JERSEY CENTRAL POWER & LIGHT COMPANY

OYSTER CREEK NUCLEAR GENERATING STATION

ECCS MODIFICATION

CORE SPRAY ELECTRICAL CROSSCONNECT

FIGURE 2-1

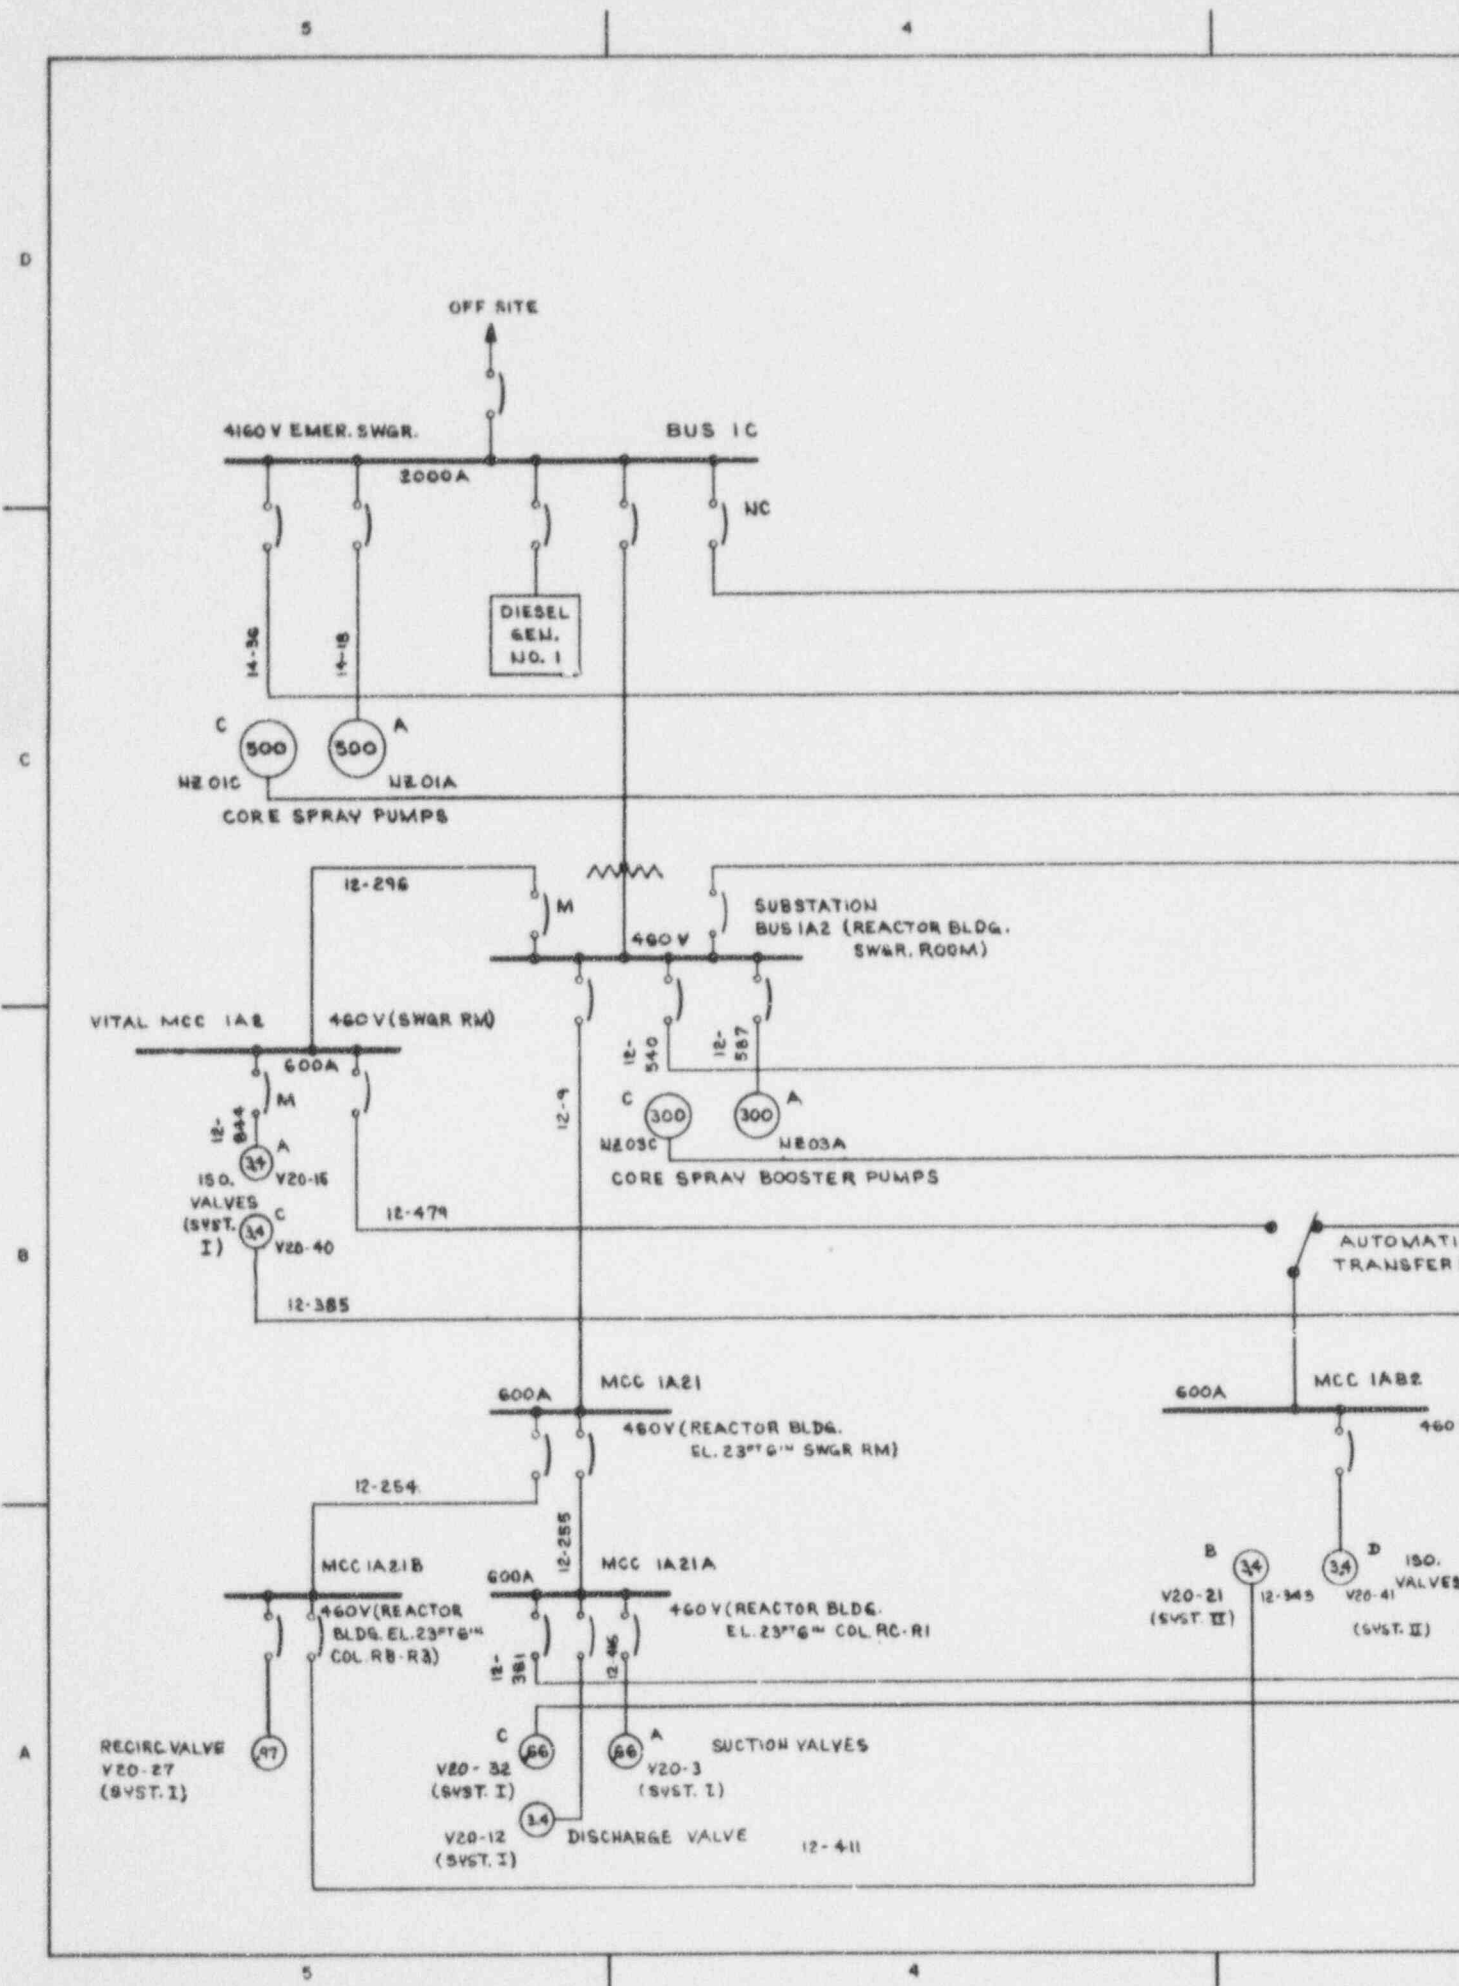
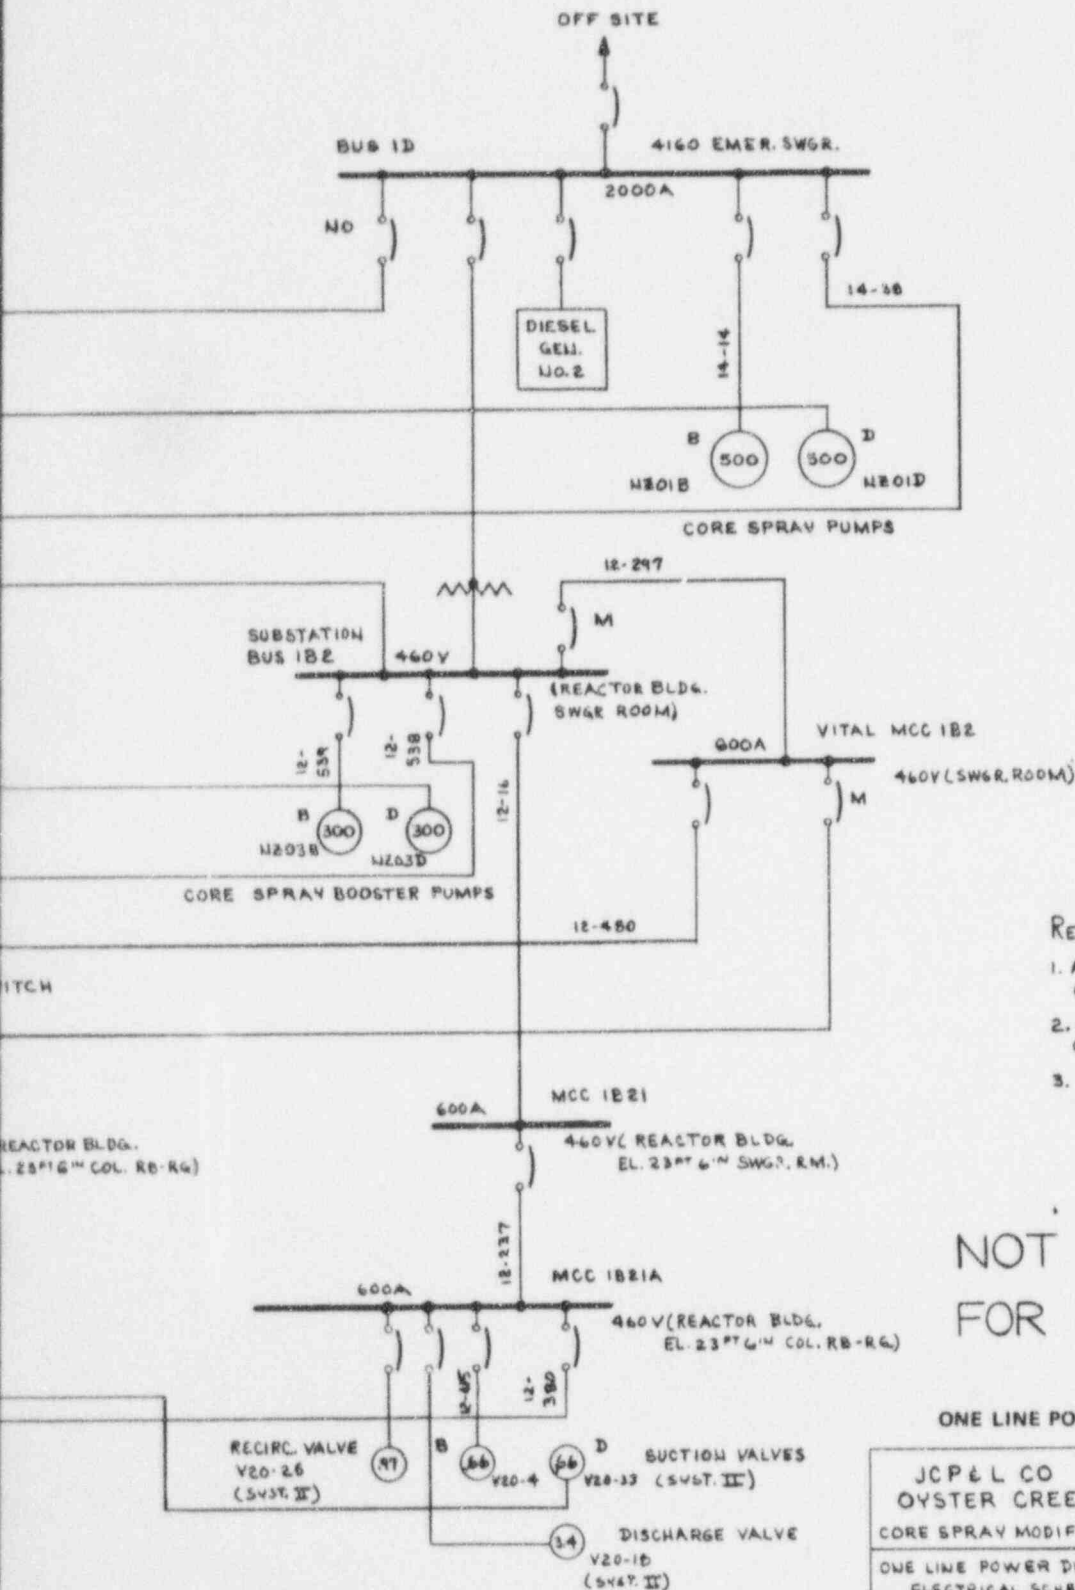
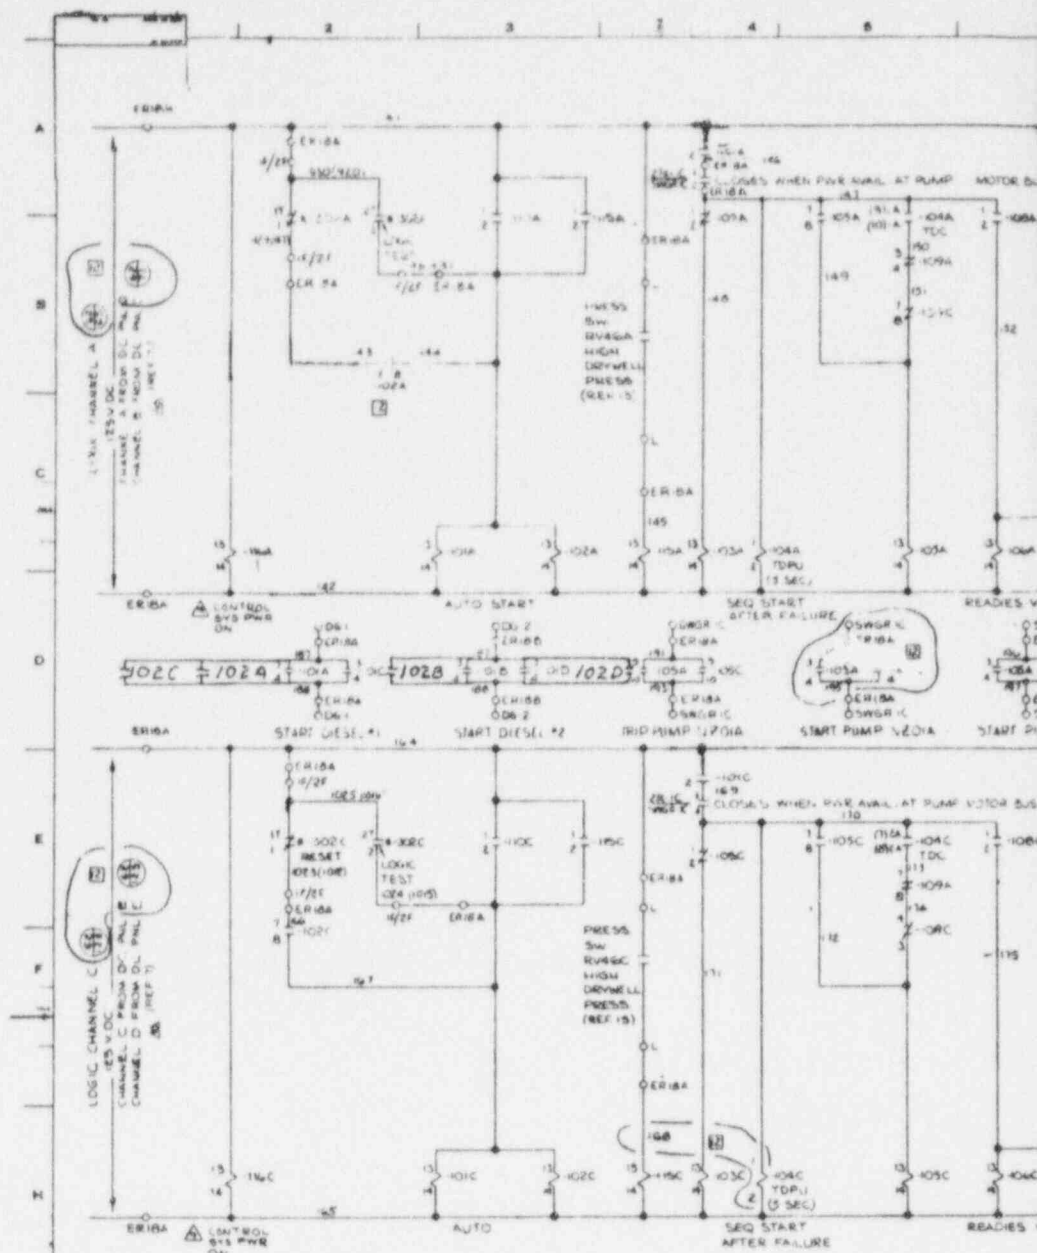
The existing AC load diagram for the core spray system components is presented in Figure 2-1. The modification to the existing load diagram is

presented in Figure 2-2. No change to the DC load schedule is required by the modification.

The modified load schedule enables both core spray fluid systems to function if one diesel generator bus is out of service. This was accomplished by powering redundant spray system components (i.e., components associated with a single core spray fluid system) from opposite buses. Each diesel generator can support the power requirements of two independent core spray fluid systems.

As presented on Figure 2-1, the currently configured MCC 1A21A provides power for CSS I suction valves V20-32 and V20-3 and CSS I discharge (test) valve V20-12. MCC 1B21A powers CSS II suction valves V20-4 and V20-33, CSS II recirculation valve V20-26, and CSS II discharge (test) valve V20-18.

To provide an independent and redundant valve-power source configuration, the suction valves V20-32 (CSS I) and V20-33 (CSS II) shall be reassigned

as shown on Figure 2-2. The current recirculation and discharge (test) valve-power source arrangement meets the independent and redundant power source requirements.
